| Office Action Summary | Application No. 10/581,314 | Applicant(s) LIMMA ET AL. | |

DETAILED ACTION

Fig. 3

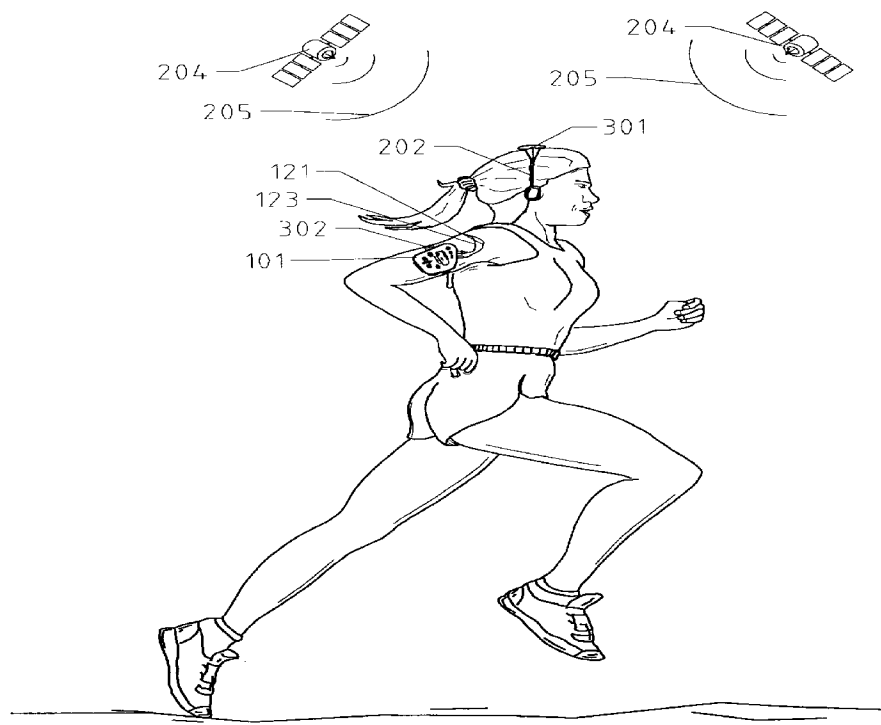
Regarding claims 1-26, Root et al. discloses a measuring device (feedback device 101 figure 6) and system (feedback device 101, headphones 202, and antenna 301, with satellite 204 to form communication). See figure 3 below -

Fig. 6

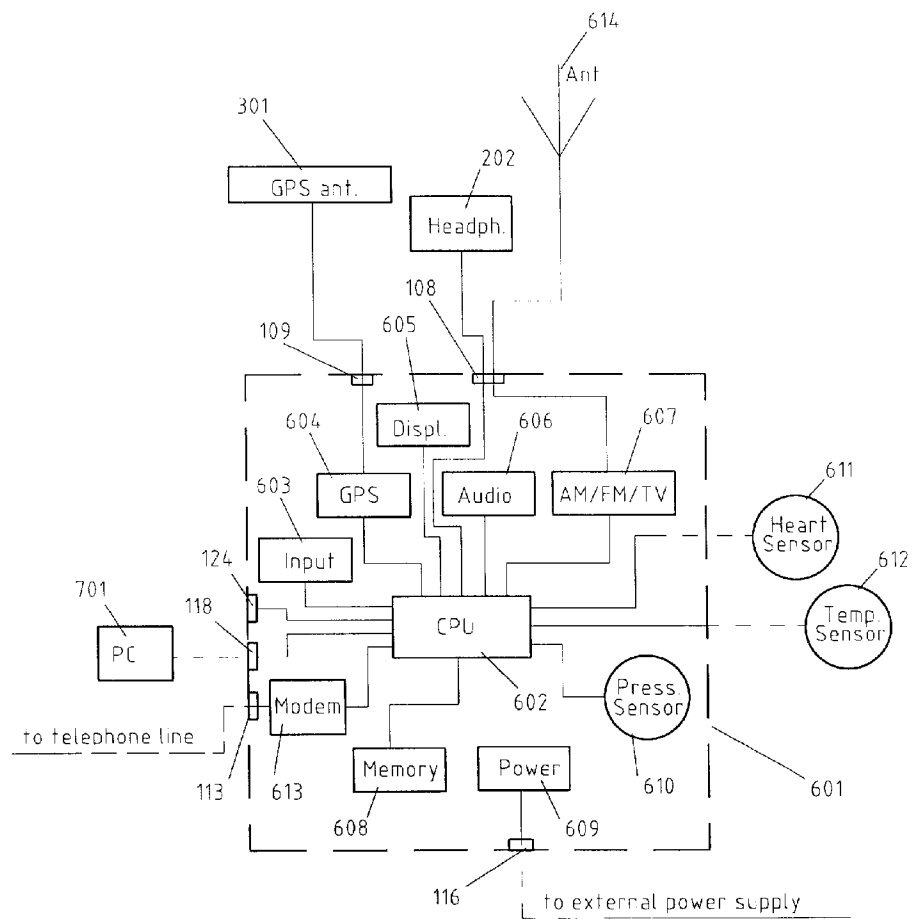
comprises: a measurement device (feedback device 101 having measurement barometric sensor 610, figure 6) comprising a first processor (CPU 602, figure 6), a plurality of measuring elements (sensors 610-612, figure 6) configured to measure a plurality of quantities relating to a sports activity, a first memory (memory 608, figure 6) configured to store measurement data provided by the measuring elements comprising a GPS receiver (604, figure 6), barometric sensor (610), heart sensor (611, figure 6), and a thermometer, (body temperature sensor 612, figure 6), and a transmitter (modem 613, figure 6) configured to transmit sports activity (running figures 2-3) information during the sports activity (running figures 2-3) to at least one a receiving device via a local communication link according to a communication protocol, (feedback transfer column 8, lines 59-67); and the receiving device (GPS receiver module 604, figure 6) comprising a receiver (antenna 301, figure 6), configured to receive a transmission from the measurement device during the sports activity (running figures 2-3) via a local communication link, wherein the transmission includes sports activity (running figures 2-3) information measured with the measurement device (feedback device 101, figure 6), a second memory (built in memory of GPS receiver module 604, figure 6) configured to store at least one definition based on which a predefined set of pieces of sports activity (running figures 2-3) information is selected from the received sports activity (running figures 2-3) information, and a second processor (built in processor of GPS receiver module 604, figure 6) configured to select the predefined set of pieces of sports activity (running figures 2-3) information from the received sports activity (running figures 2-3) information based on the at least one definition, which is defined based on the sport in

question, stored on the second memory (built in memory of GPS receiver module 604, figure 6); and at least one feedback device (feedback device 101, figure 6) configured to provide the at least one individual with feedback on a user interface display based on the selected sports activity (running figures 2-3) information, (column 4, lines 4-67, column 5, lines 1-67, figures 1-12). See figure 6 below for electrical schematic of the feedback device –

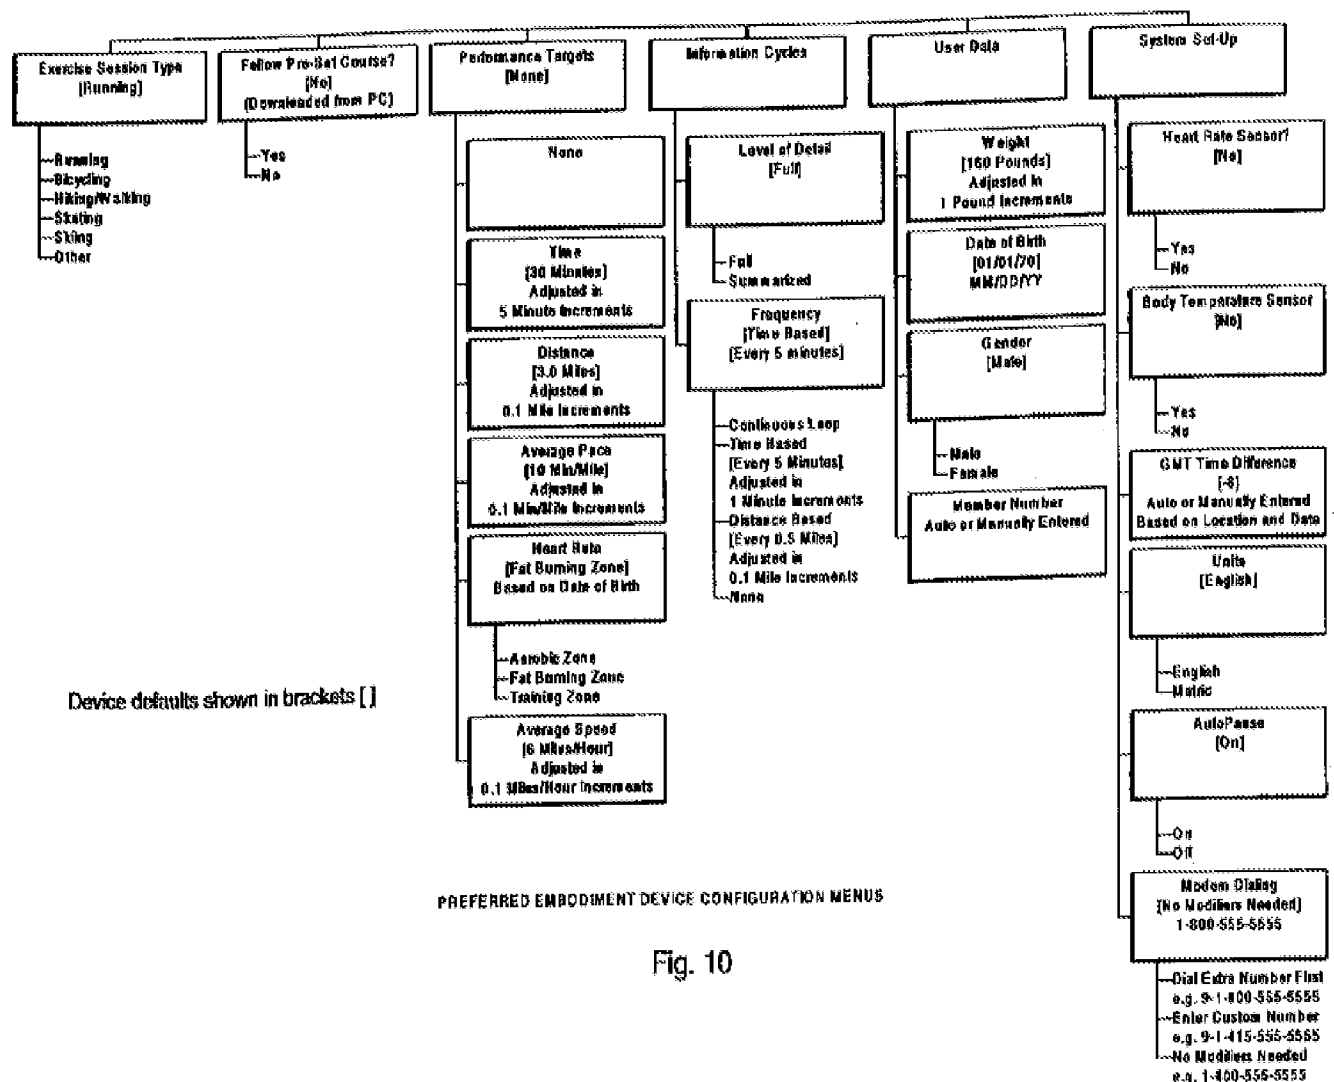
Root et al. also discloses the system and method comprises the feedback device (101, figure 6) a display having graphical features, geographic position on display 112, column 4, lines 10-15), voice signals (audio module 606, column 35-64), ear piece, (headphones figures 2-5), and a speaker (column 11, lines 1-5). Root et al. also discloses a menu and selection choices for the desired activity, (column 6, lines 42-49, figure 10). See figure 10 below for menu selection and activity settings –

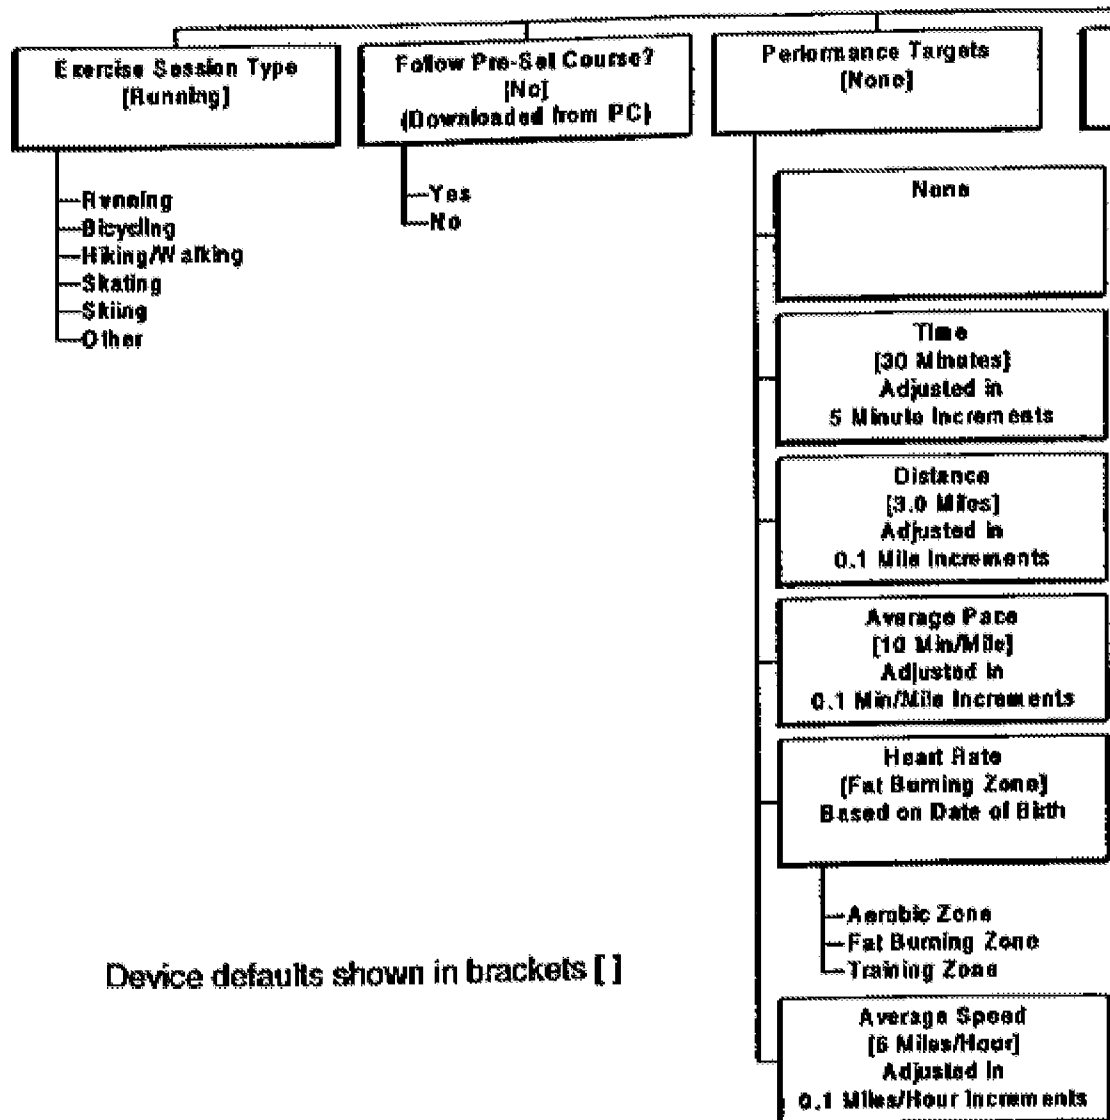
Also in figure 10 Root et al. shows the selection of the sport in question (run, bike, skate, ski, and other) and target/pieces of information to inquire about the sport in question –

Fig. 8

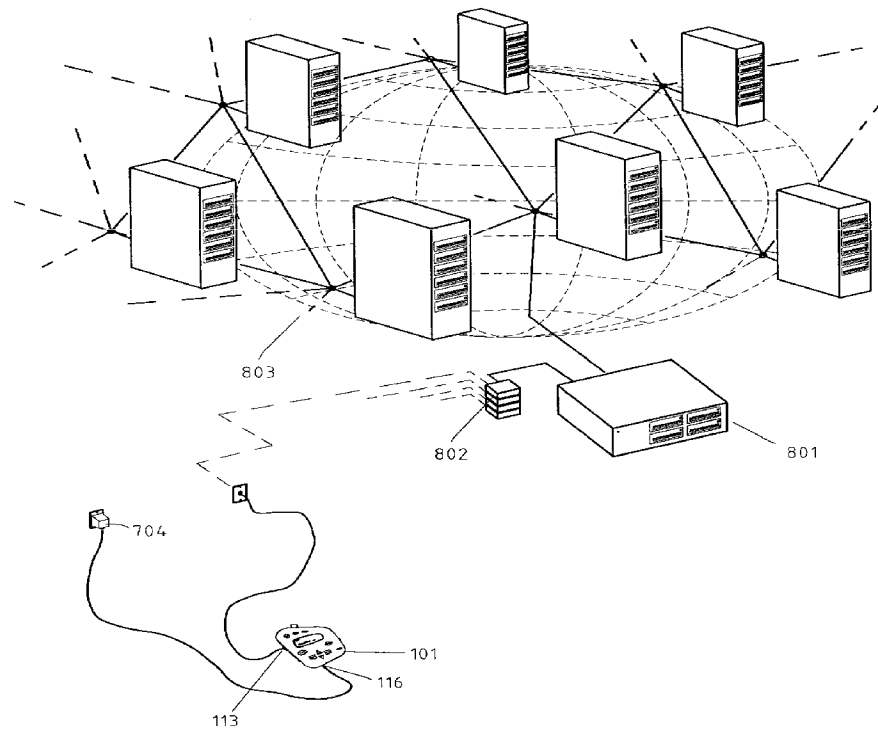
Applicant's arguments filed 10/19/09 have been fully considered but they are not persuasive. Per the amendment to the specification and drawing errors examiner contends it is not clear how many devices, interfaces, and/or displays there are and the arguments with respect to a plurality of receiving devices is moot. Also, with respect to root et al's feedback device only being a single device, Root discloses the feedback measuring device interacting/transmitting with more than once receiving device, (column 6, lines 1-67, figures 8-9).

Root et al. states: “*GPS-based personal performance monitor and feedback device 101 connected to a remote computer 801 and modem bank 802 via its internal modem 613 and a standard telephone line plugged into connector 113*”, (column 6, lines 12-29, figure 8).

Figure 8 below shows the feedback measuring device transmitting data to a plurality of receiving devices -
